ORIGINATION FORM

Proposed Revisions to a Standard Plans Index
(Please provide all information — Incomplete forms will be returned)

Index Number: 521-650
Sheet Number (s): 1
Index Title: Light Pole Pedestal - Wall Coping

INDEX 521-650	SHEET 1 of 3
-------------------------	------------------------

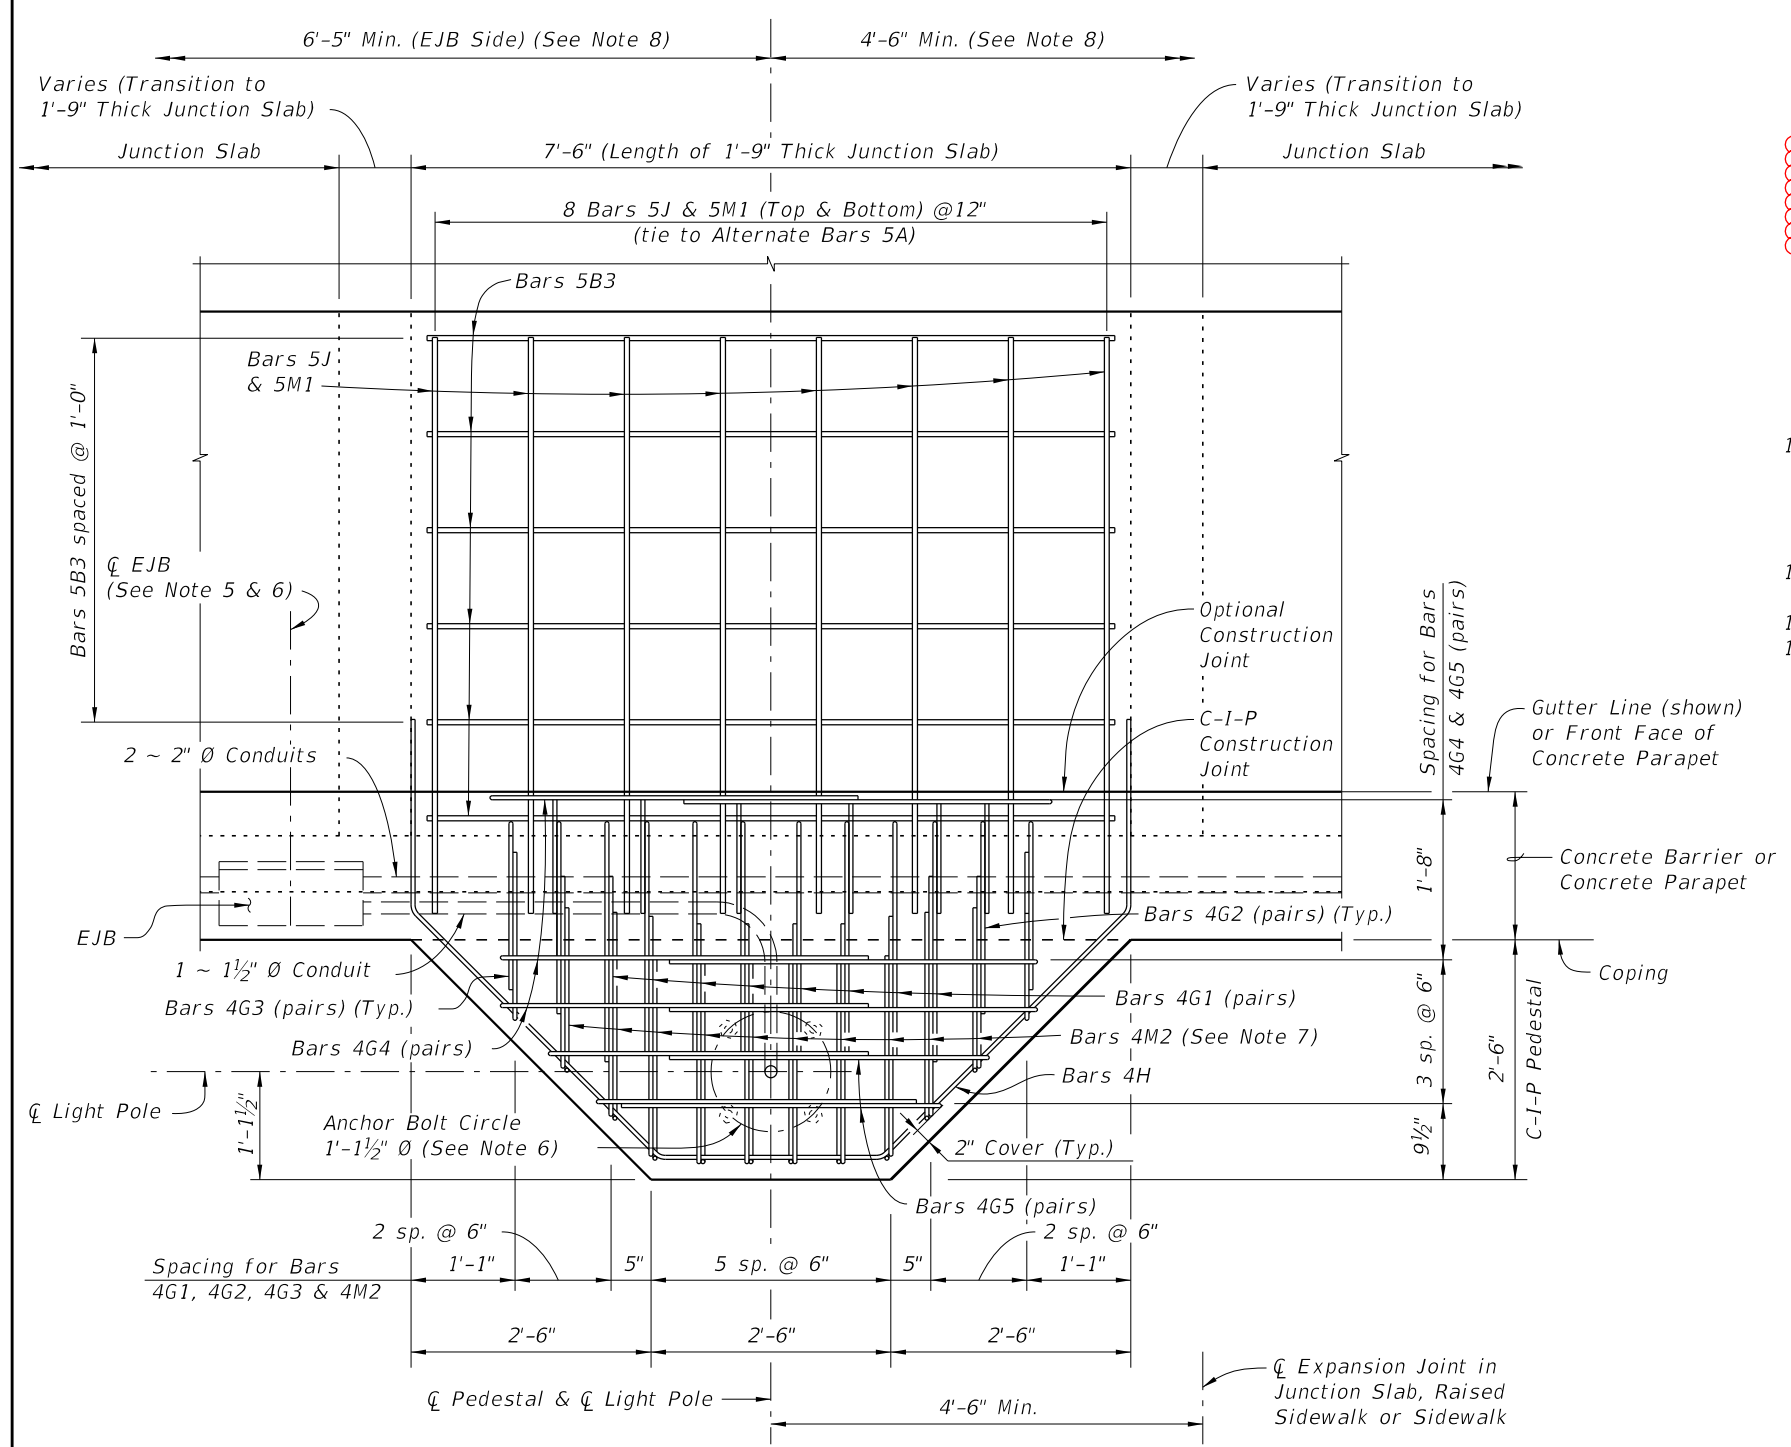
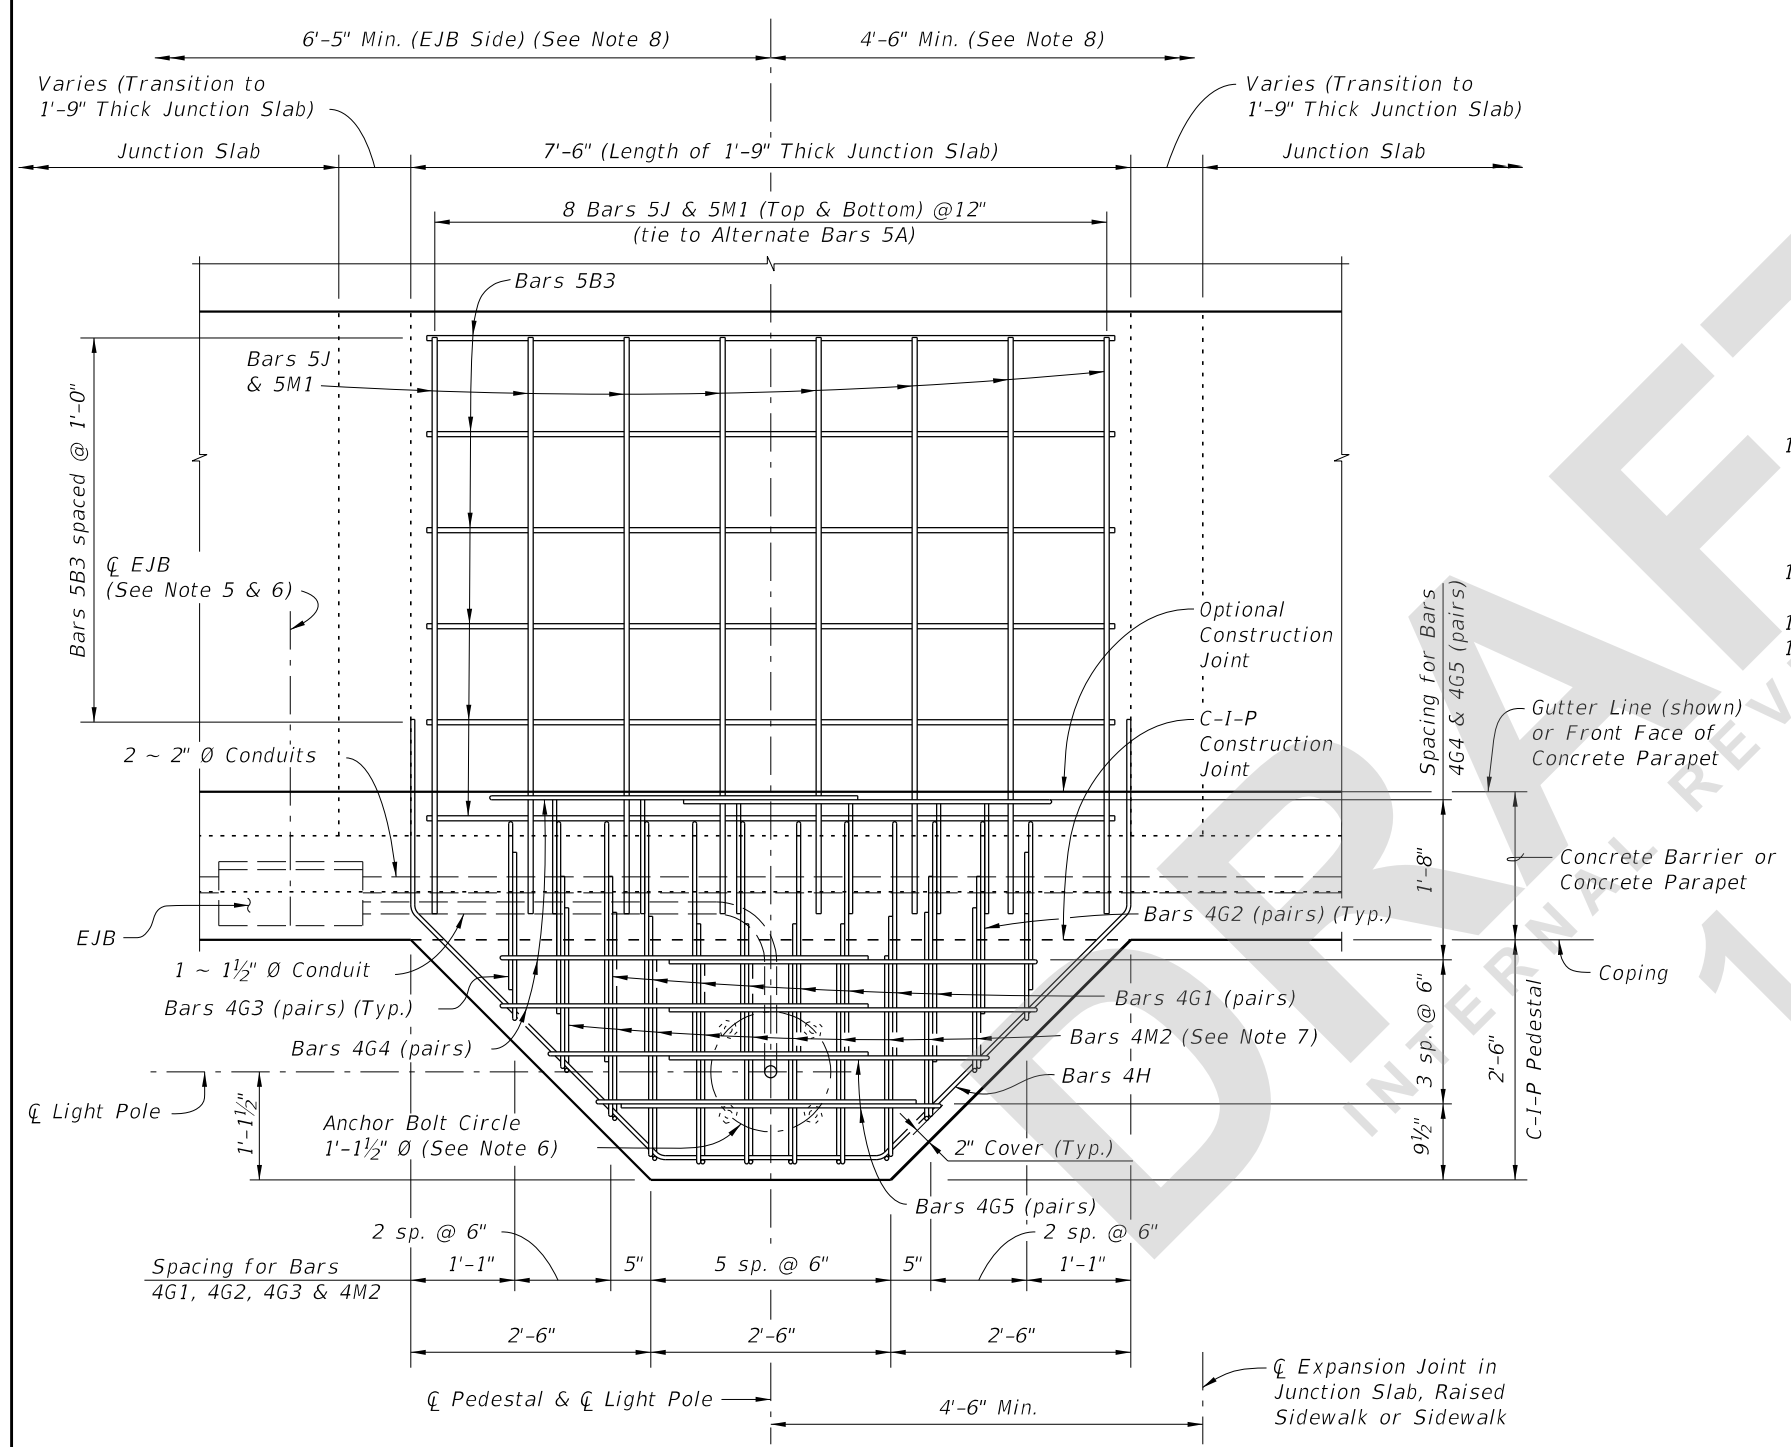
Sheet 1, Note 5: Added reference to Index 630-001 (Conduit Details - Embedded) for information on embedded junction boxes and conduits.

Added reference to provide continuity between Standards and improve understanding for designers and contractors wanting to verify that these Indexes share details. This particular topic received designer questions.
